YEAR  
1989 - 90

MODEL  
LEGEND

BULLETIN NO.  
93-019

## Product Update: Legend Igniter

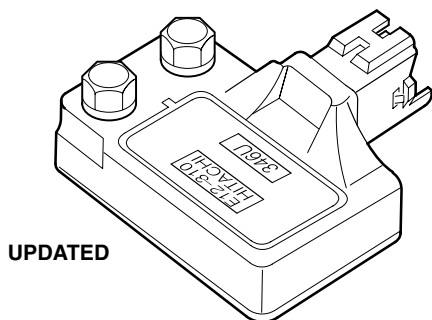
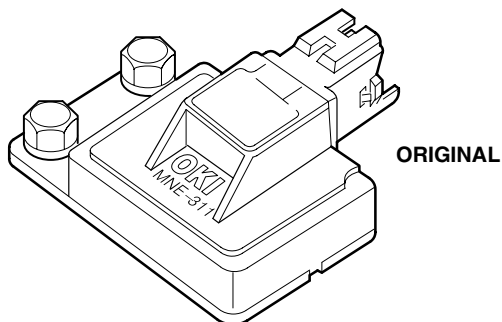
The igniter may fail. If this happens, the engine will not start. This product update is being conducted to help eliminate any possibility of igniter failure.

Replace the igniter with the updated part listed under PARTS INFORMATION.

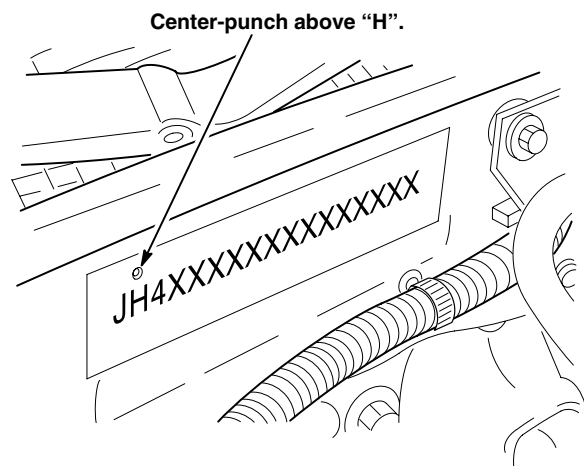
1. Inspect the igniter mounted on the left inner fender panel.
  - If the mounting bolts go through the heat sink, it is not an updated igniter. Continue with this replacement procedure.
  - If the mounting bolts go through the igniter body, it is an updated igniter. Go to step 6.

2. Disconnect the 4-pin igniter connector.
3. Remove the igniter mounting bolts and the igniter. Discard the bolts and the igniter.
4. Connect the 4-pin connector to the new igniter.
5. Install the igniter with the new bolts that came in the kit. Torque the bolts to 10 N·m (1.0 kg·m, 7 lb-ft).
6. Center-punch a completion mark above the "H" in the engine compartment VIN.
